BEFORE THE PLANNING COMISSION OF THE CITY OF SALEM

IN THE MATTER OF APROVAL OF)	ORDER NO. SUB-ADJ21-05
CONSOLIDATED TENTATIVE)	
SUBDIVISION AND CLASS 2)	TENTATIVE SUBDIVISION AND
ADJUSTMENT CASE NO. SUB-ADJ21-05)	CLASS 2 ADJUSTMENT CASE
FOR PROPERTY LOCATED AT 2230)	NO. 21-05
DOAKS FERRY ROAD NW)

Section 1. The Salem Planning Commission overturns the decision of the Planning Administrator and DENIES Subdivision Tentative Plan, and Class 2 Adjustment Case 21-05.

Figure 1: Image from Salem Keizer Local Wetlands Inventory (1999)

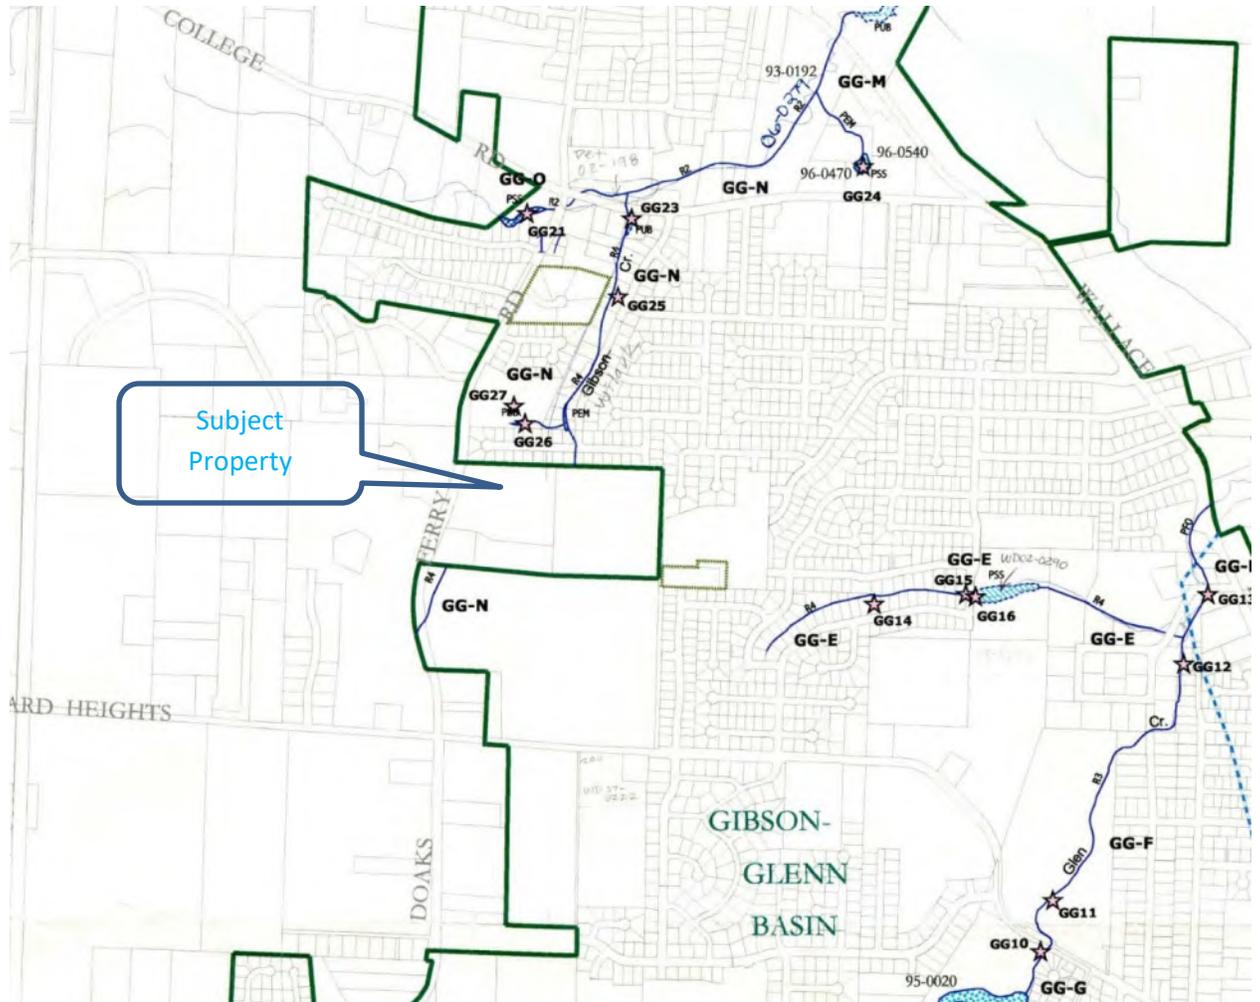
1. The application fails to identify two headwater streams tributary to Wilark Brook as required by SRC 205.030 (a) (10) and (11) *to locate waterways* (10) and SRC 250.005 (c) submittal requirements *to locate natural features including creeks*.
2. The application does not include a wetland inventory. The subject property was outside the City as shown on the Salem Keizer Local Wetland Inventory that was conducted in 1999 (Figure 1).

The approval on page 17 erroneously asserts: “The Salem-Keizer Local Wetland Inventory (LWI) does identify wetlands on the subject property.”

Figure 2: Stream Confluence Tributary A and Wilark Brook (6/9/2021)

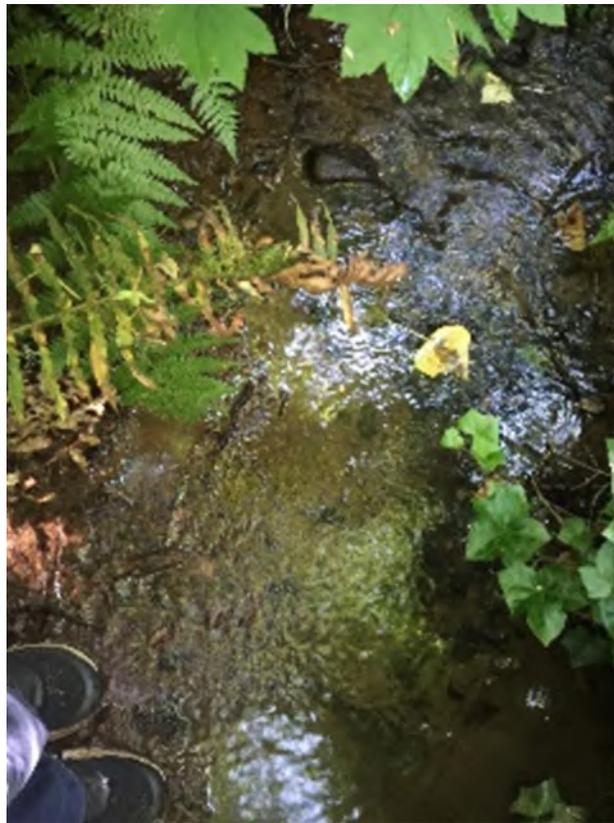
The applicant for **SUBDIVISION / CLASS 2 ADJUSTMENT CASE NO.: SUB-ADJ21-05** has failed to identify two waterways / watercourses on the property. Contour lines and the LiDAR map document tributary channels to Wilark Brook. Upon a site visit, both channels are spring fed streams that are tributaries to Wilark Brook. The streams were flowing in early June after a significant time of drought. Both tributaries were flowing streams with springs emerging from the banks and wetlands where springs and seeps entered the tributaries. Neither of the tributary streams nor their 50-foot riparian corridors are identified in the application. Figures 2 and 3 are photographs of the two streams showing flow reaching the confluence with Wilark Brook.

These two existing streams are not identified in the application. The designation of these streams and their 50-foot riparian corridors should be identified under the provisions SRC Chapter 808 and appropriate provisions made for their protection.

Figure 4: Map showing Tributary A

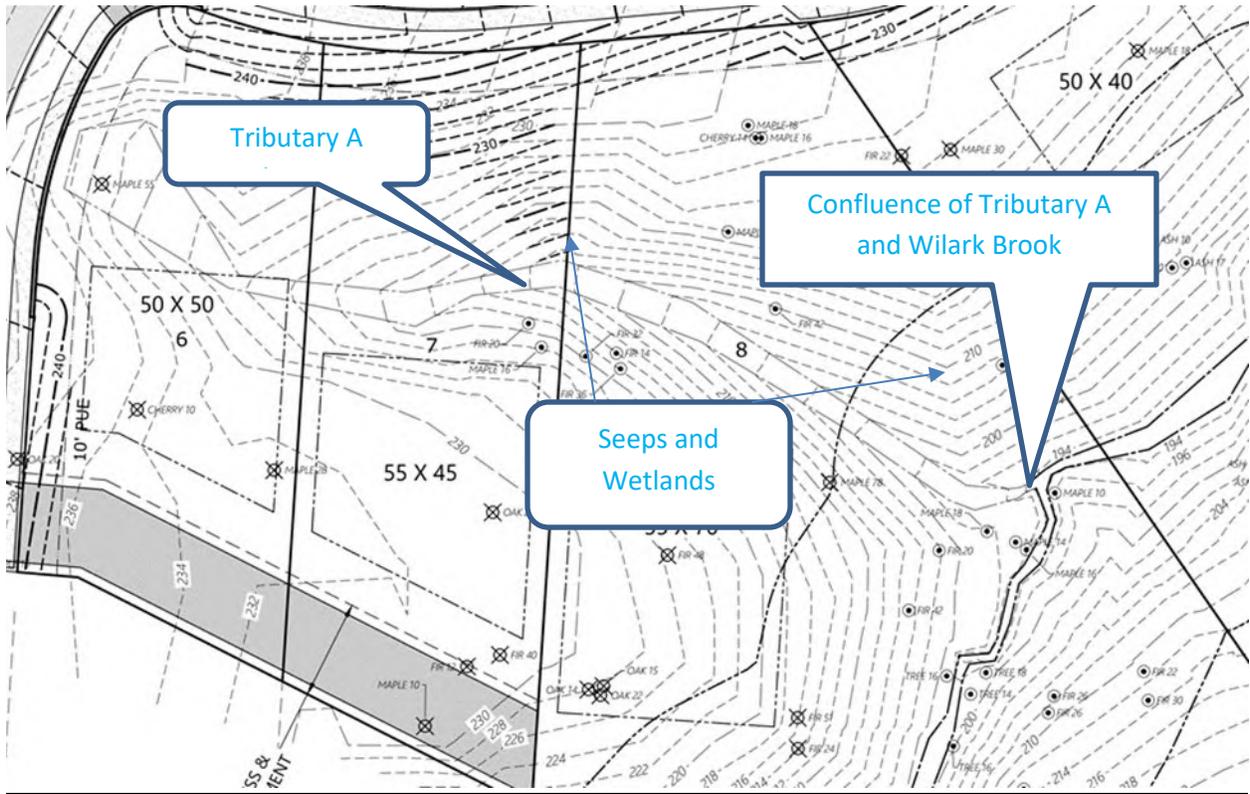
As shown in the application, the building envelope of Lot 6 fully occupies the riparian corridor of Tributary Stream A and the NE corner of the envelope extends directly into the stream. The building envelopes of Lot 7 and Lot 8 occupy the riparian corridor of Tributary Stream A and nearly extend into the stream.

Figure 7: Habitat Tree in the Riparian Corridor of Tributary B (photo 6/9/2021)

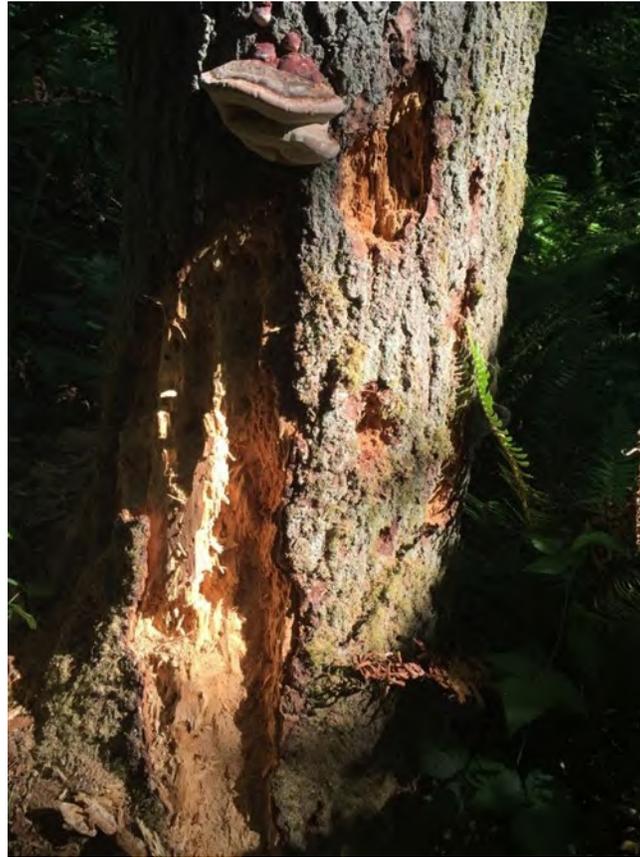
Other wildlife habitat values include the riparian cover to the tributary streams that help to maintain cool water in Wilark Brook and associated wildlife habitat such as the snag (Figure 7) providing habitat for cavity nesting birds and animals.
